Publication of EMF-92-081(P)(A) Revision 1, "Statistical Setpoint/Transient Methodology for Westinghouse Type Reactors"

EMF-92-081(NP)(A)
Revision 1

Statistical Setpoint/Transient Methodology for Westinghouse Type Reactors

GENERAL QUESTIONS PERTAINING TO BOTH
THE WESTINGHOUSE AND COMBUSTION ENGINEERING
STATISTICAL SETPOINT/TRANSIENT METHODOLOGY

Figure B.8 Probability Density for Power From Temperature Uncertainty

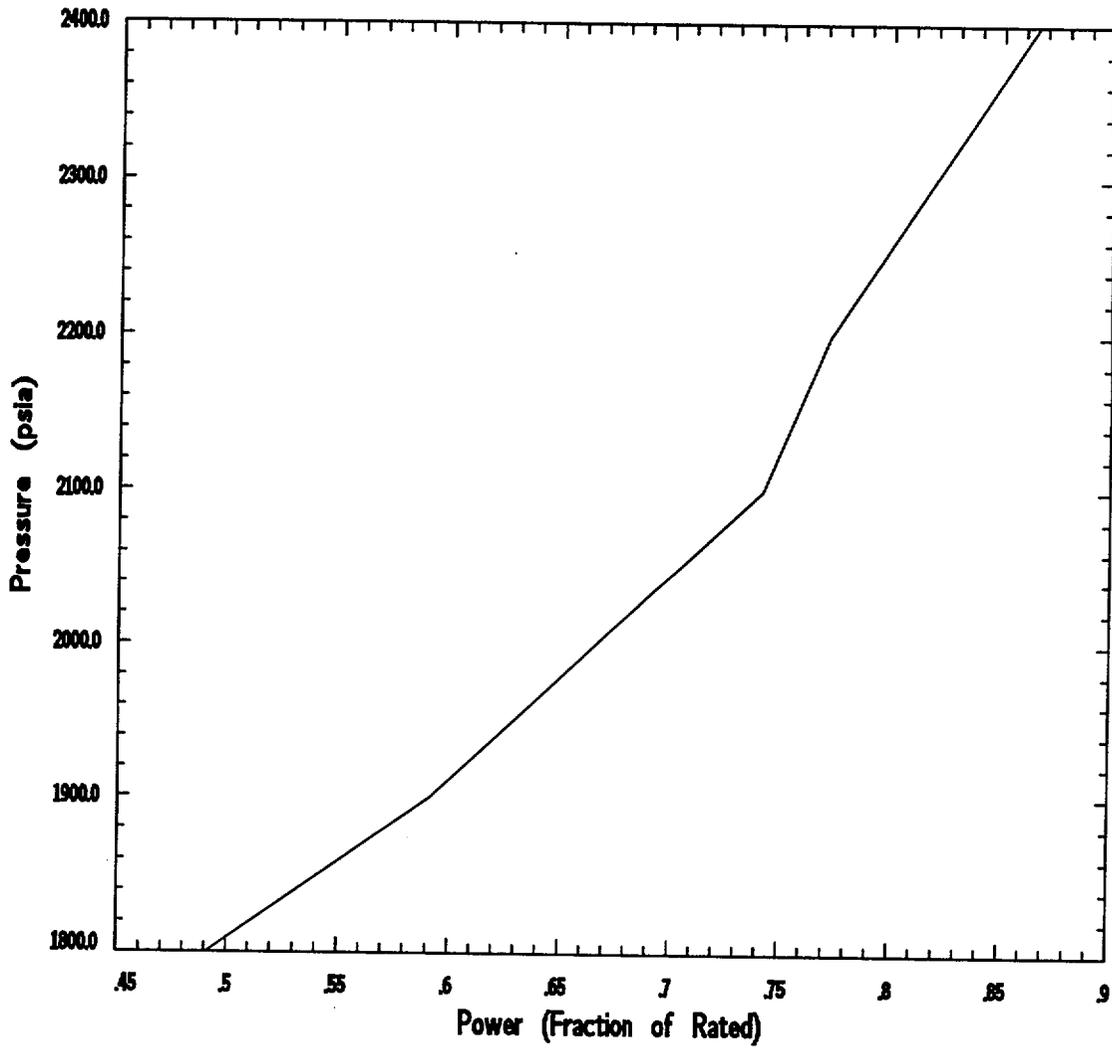
19. Page B-19, Figure B.8

Please explain the method used to generate this figure.

19. Pg. B-19, Figure B.8,

Please explain the method used to generate this figure.

The description of the transformation of temperature and power uncertainties is given on page B-3. The curve in Figure B.8 is $f_{\alpha,T}$. The subscript denotes the uncertainty in power coming from the uncertainty in temperature. [
